1CAN021303

SUBJECT: Response to Request for Additional Information
Request for Relief ANO1-ISI-021
Arkansas Nuclear One, Unit 1
Docket No. 50-313
License No. DPR-51

**Response to Request for Additional Information
Relief Request – ANO1-ISI-021**

Figure 1

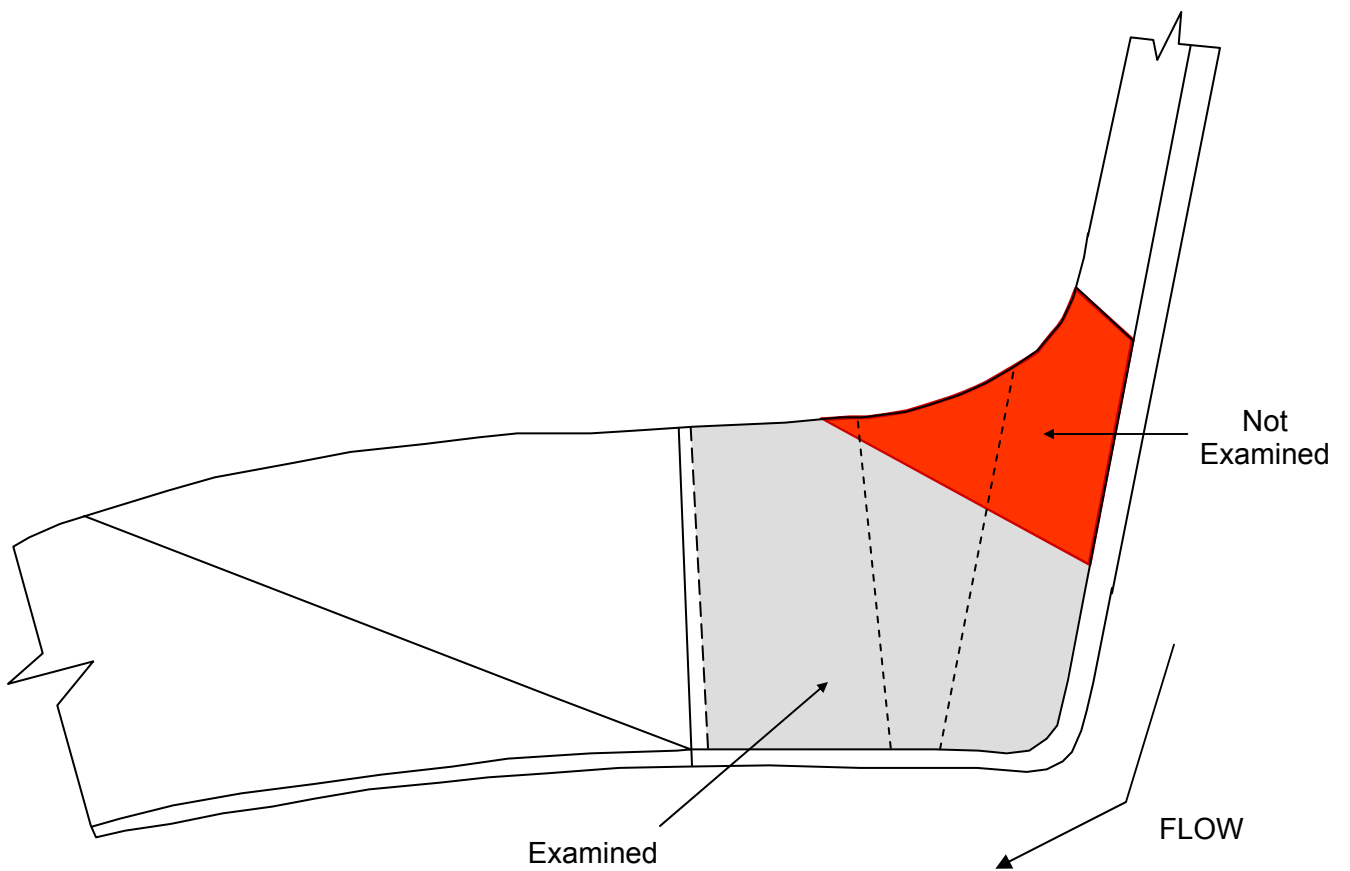
6. There appears to be a discrepancy between the stated coverage percentages and the “uninspected area” shown in the figures. How was coverage calculated? Please provide a coverage map showing the areas that were missed.

Component 05-012 - Pressurizer Spray Nozzle to Head weld, was reported to have cumulative coverage of 36.6%, which is the average of the four scans taken each with the 45° and 60° angle beam transducers across the base material on the nozzle side, the weld and the base material on the head side of the component.

Scan illustrations appear to indicate more coverage than the reported 36.6% due to the 60° angle providing approximately 69% scan coverage in one direction across the weld from the vessel head side. The cumulative scan coverage is reduced considerably because the scan from the nozzle side could not be performed, and the circumferential scans could not be performed all the way across the Code-required surface area.

Refer to attached Figures 1 and 2 which illustrate the extent of examination volume that was interrogated to some extent with the ultrasonic process by at least one examination angle.
